Output specs to complement TDECQ for IM-DD PMDs

Adee Ran, Cisco

Abstract

Experimental Data: “Good” TDECQ, “Bad” Link Performance

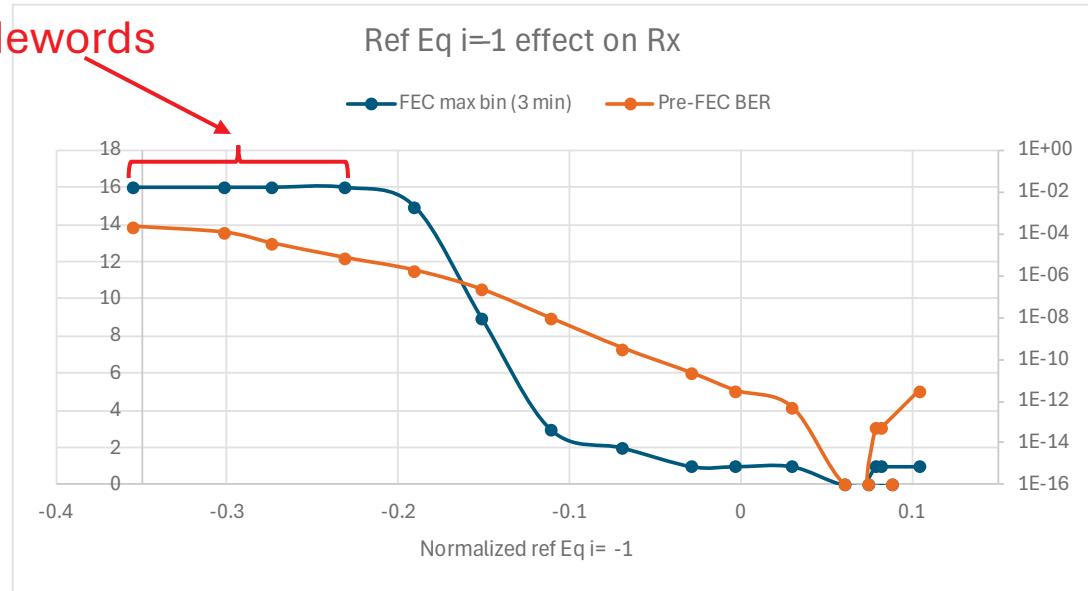
Red when there is post-FEC error

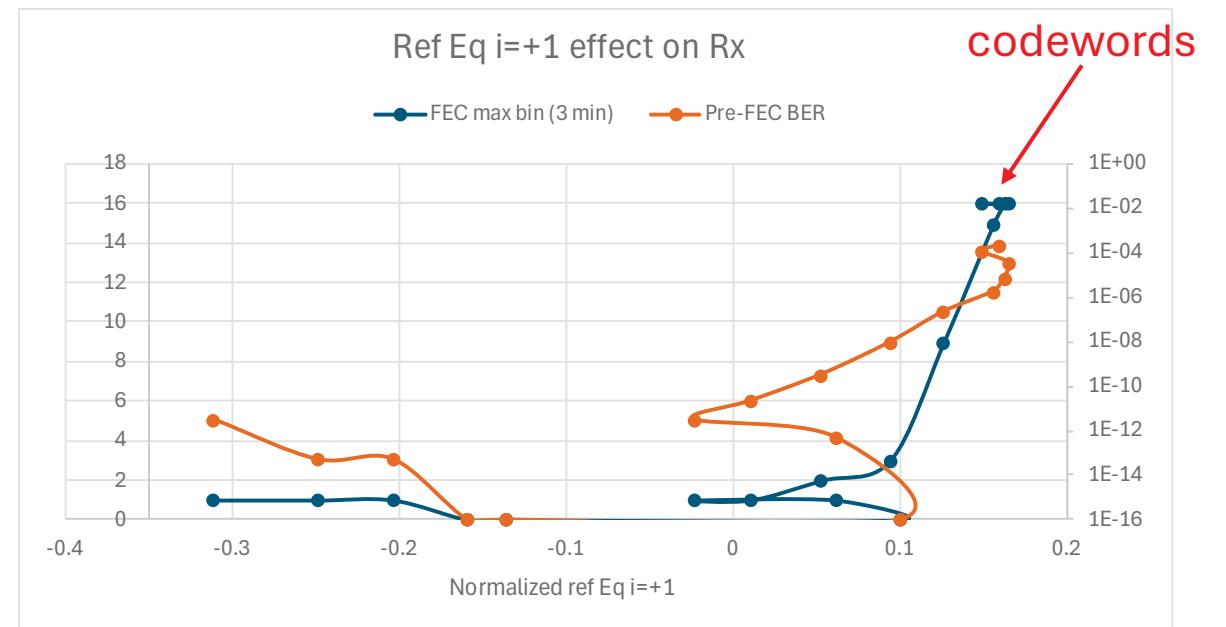
- Tx equalization can be characterized by the reference FFE precursor FFE(2) ($i=-1$) and postcursor FFE(4) ($i=+1$)
- Strong Rx equalization (in any of the two) corresponds to poor Tx equalization
- When strong Rx equalization is required, the receiver shows bad BER and high FEC bins.

Uncorrectable codewords

Under-equalized Bad region

Observations (2)

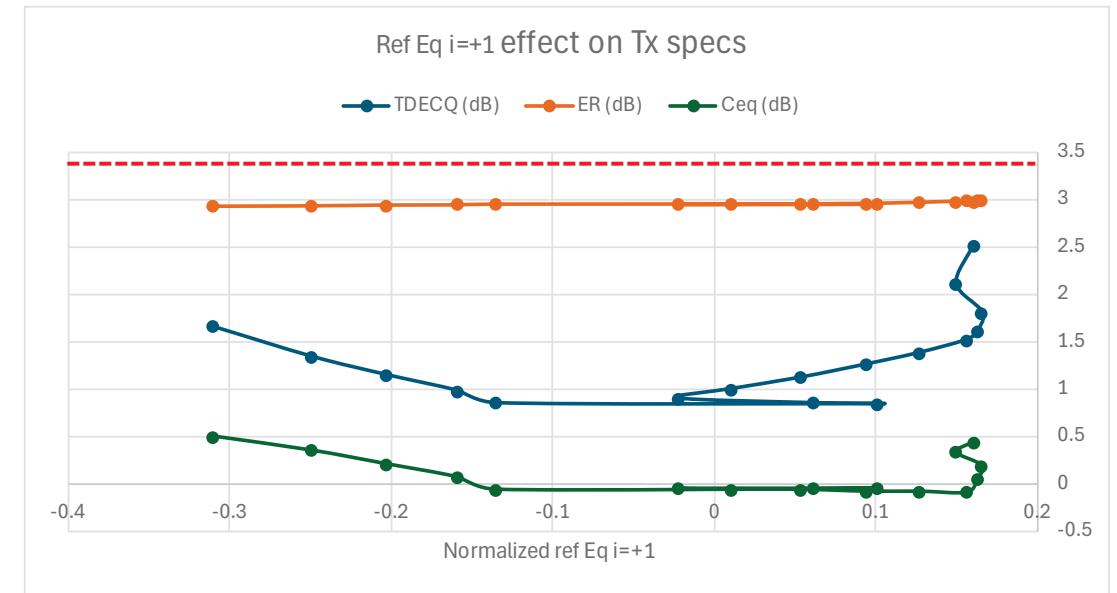
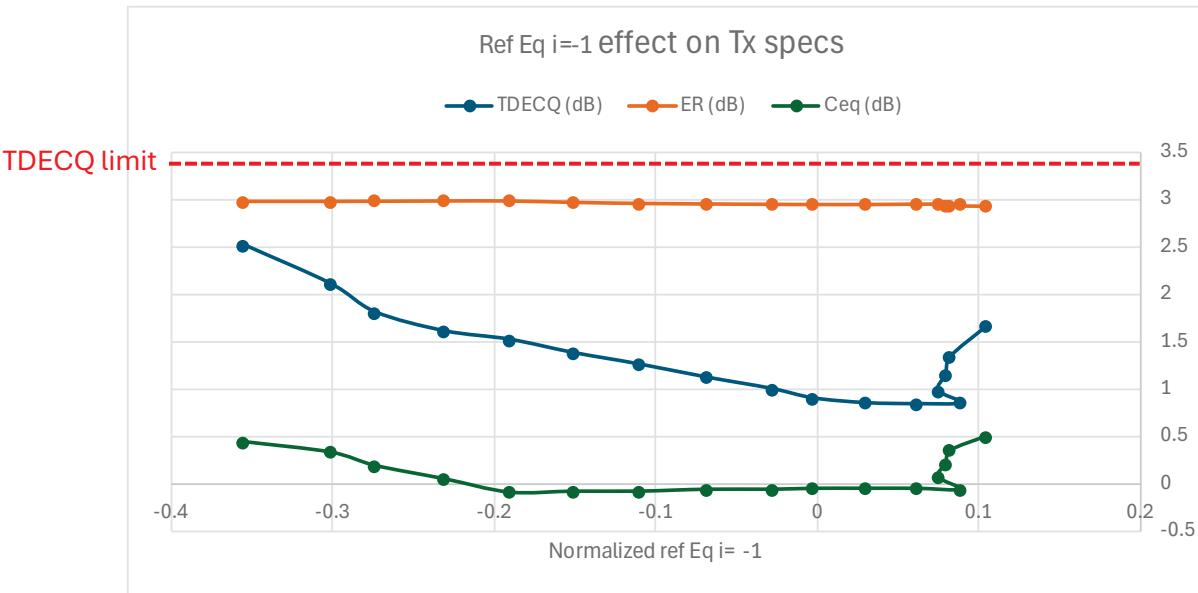
- TDECQ is affected by the equalization, but spec is <3.4 dB – met in all cases.
- Ceq is weakly sensitive to equalization (it is not a spec parameter).
- ER is constant across the data set.

Observations (3)

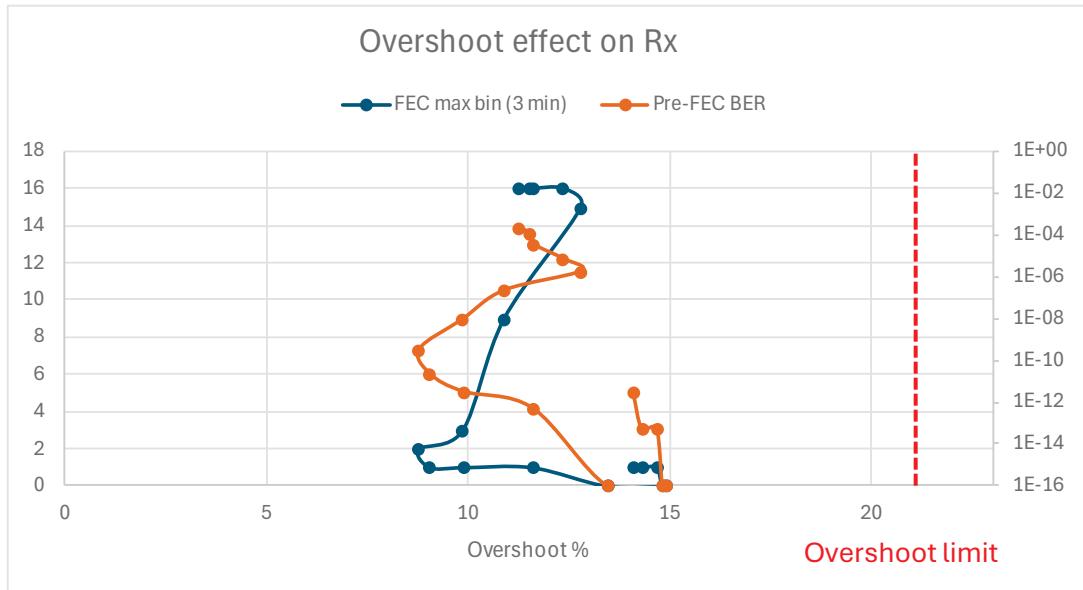
- Overshoot is affected by the equalization, but has no correlation to Rx performance. Spec (<22%) is met in all cases.
